| 6/16/82 | Added General Note III i. |

STATE OF HAWAII  
DEPARTMENT OF TRANSPORTATION  
LAND TRANSPORTATION FACILITIES DIVISION  
**INSTALLATION OF  
UNIVERSAL TESTING MACHINE**  
Project No. HWY-0-03-81

Scale: As Noted  
Date: May, 1982  
SHEET NO. 1 OF 3 SHEETS

**SECTION A-3/3**  
Scale: 3/4" = 1'-0"

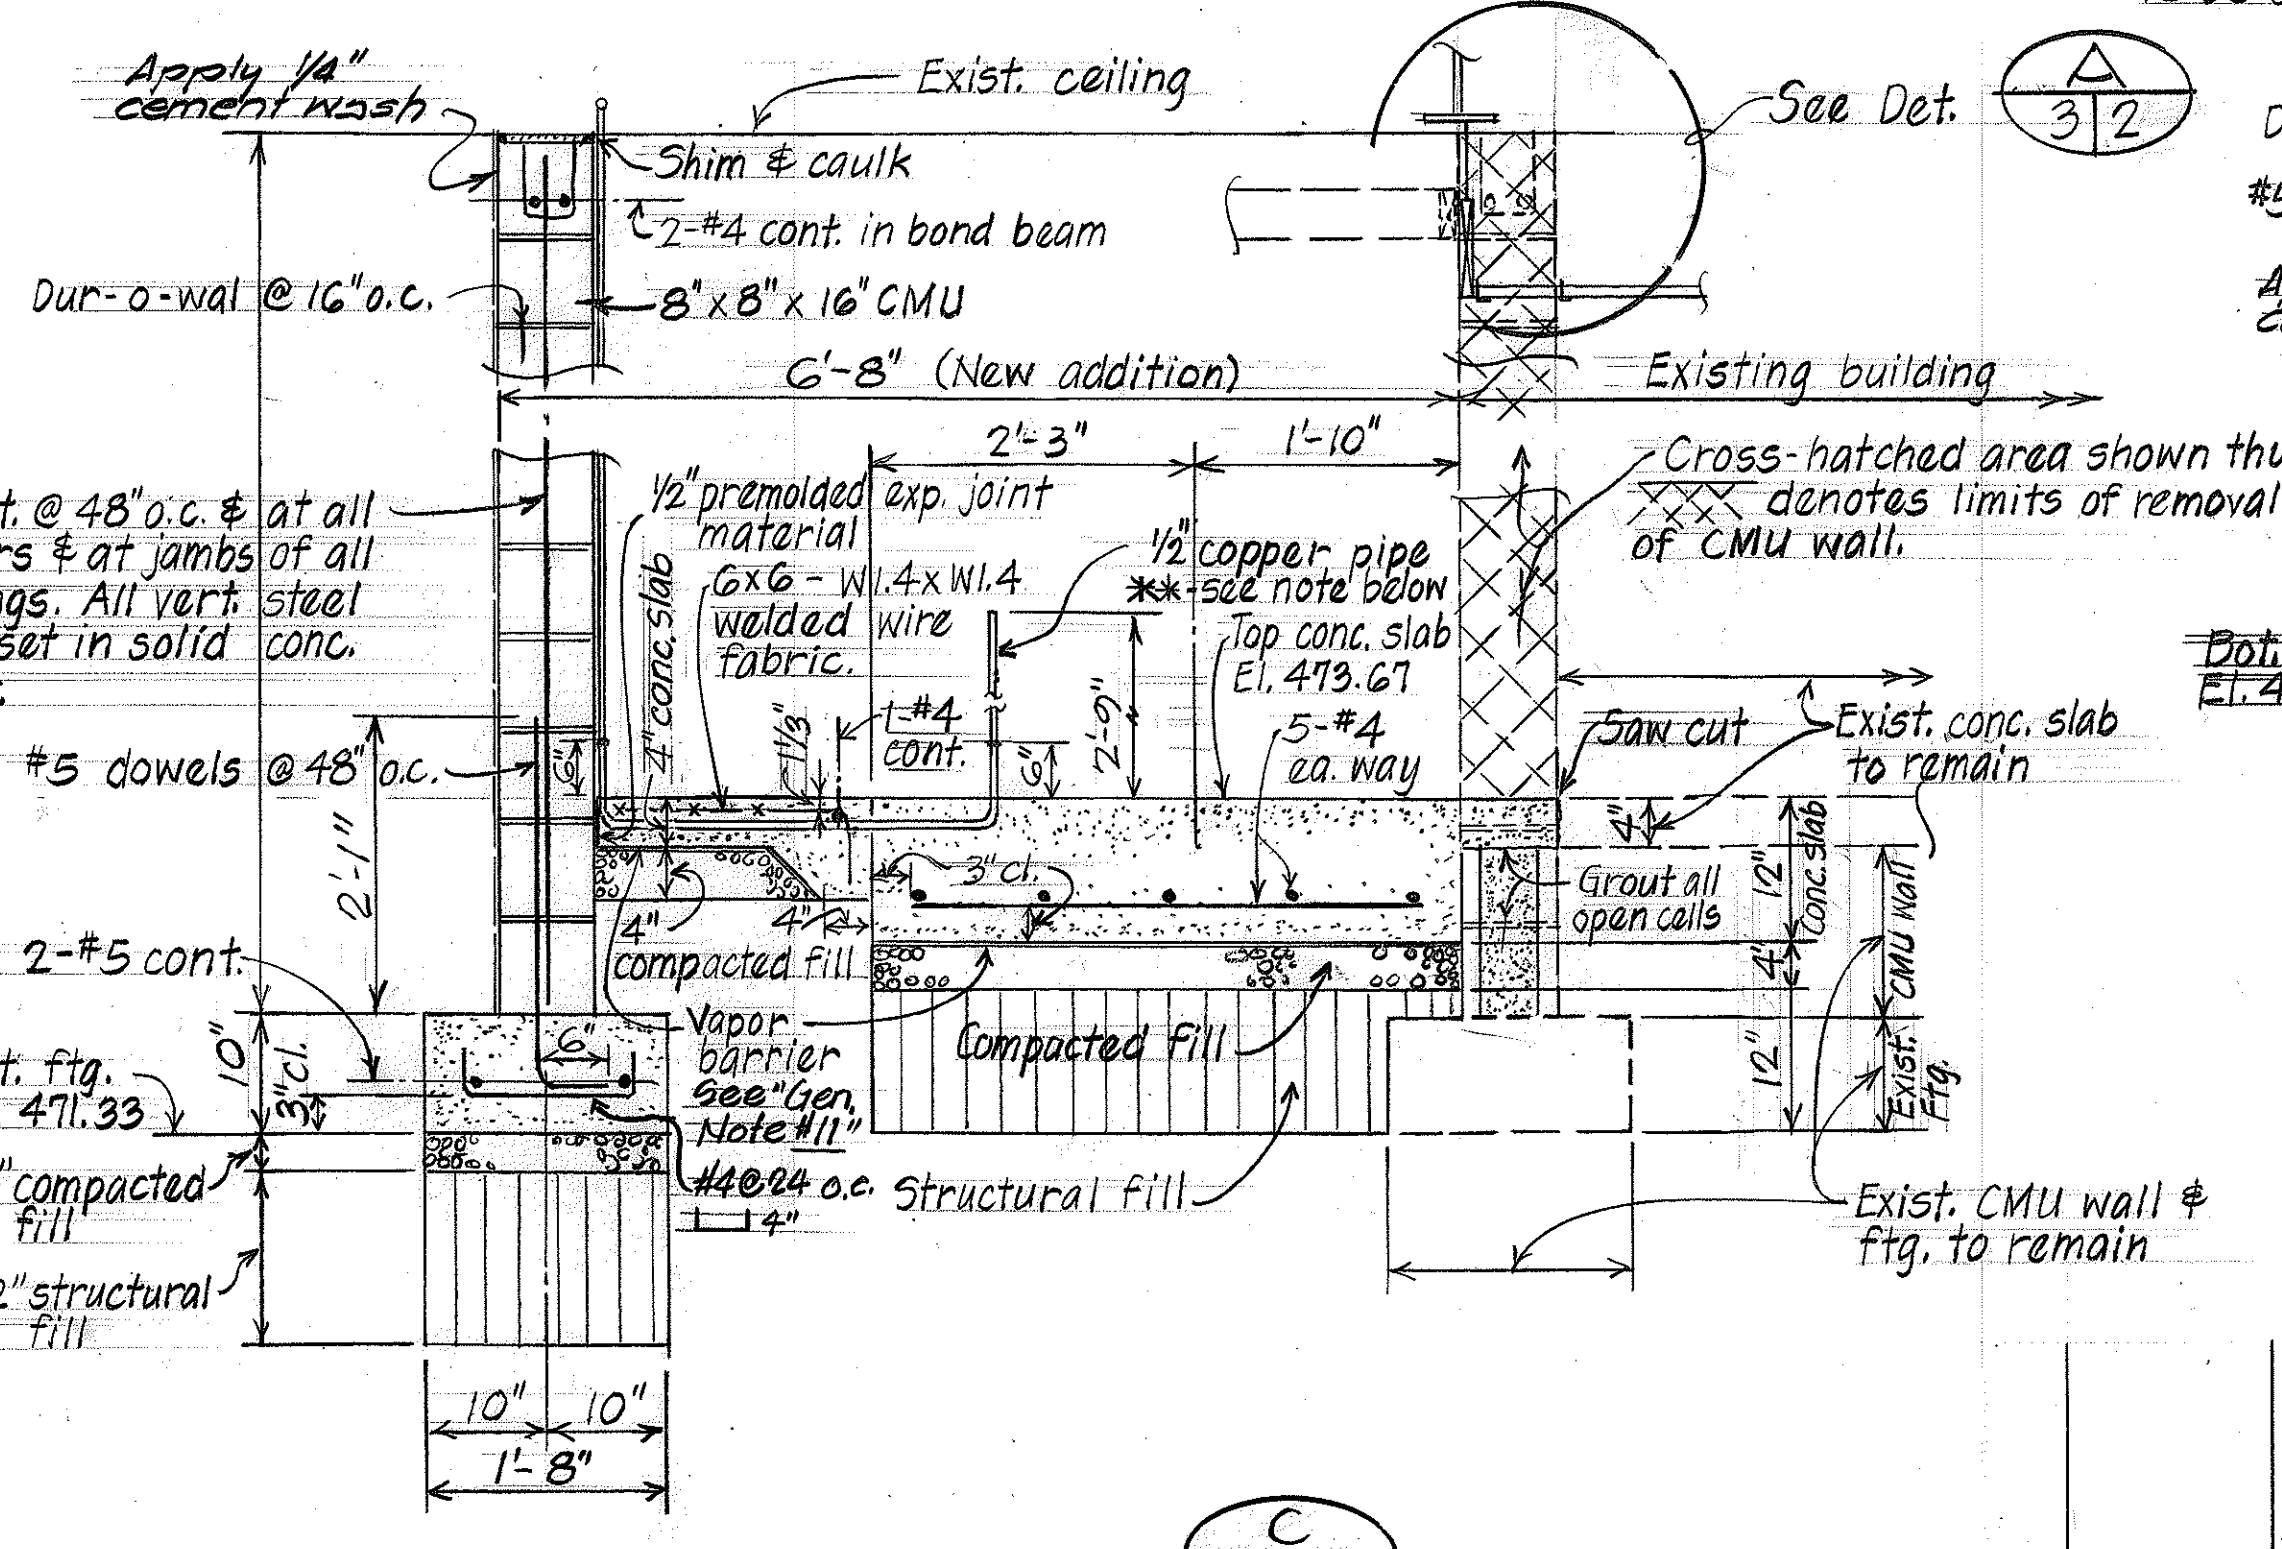
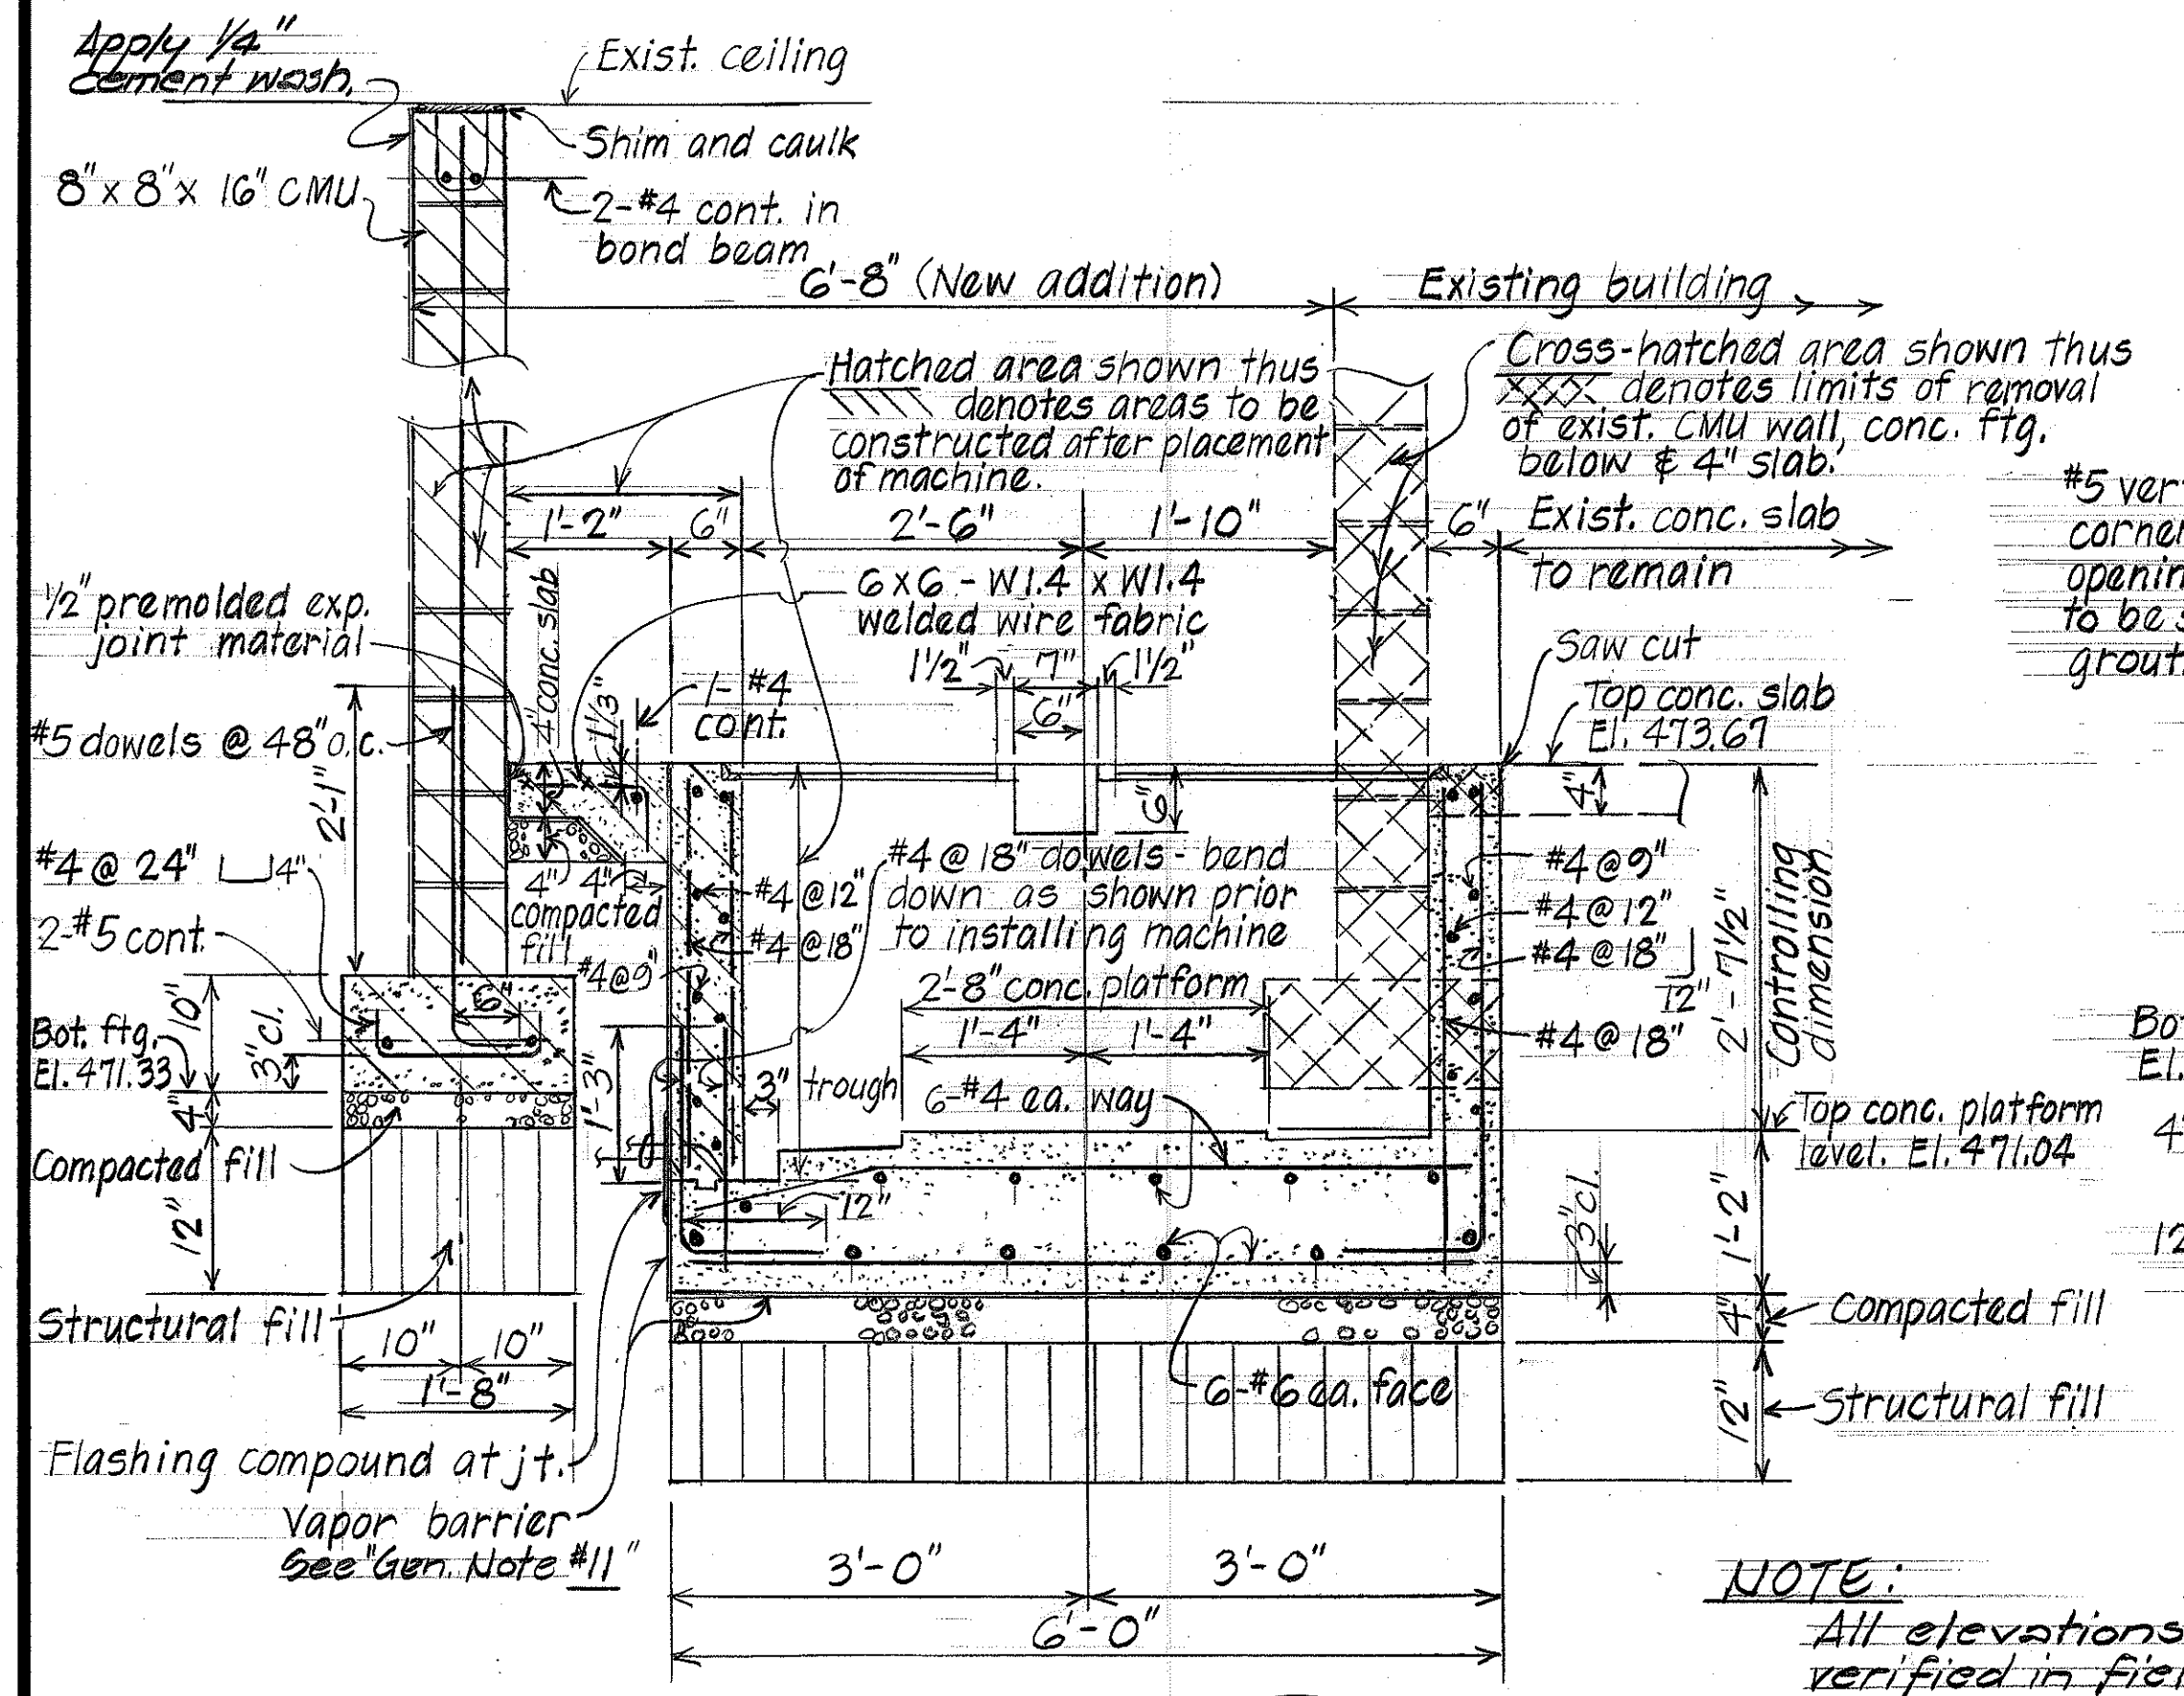
6/16/82 SECTIONS A-3/3 & C-3/3 revised to show installation of copper pipes for compressed air. Added note for compressed air. Additions to Vapor Barrier.

**\*\*NOTE:**  
Contractor to make all pipe connections necessary for installation of compressed air. All dimensions are approximate and are to be verified in the field.
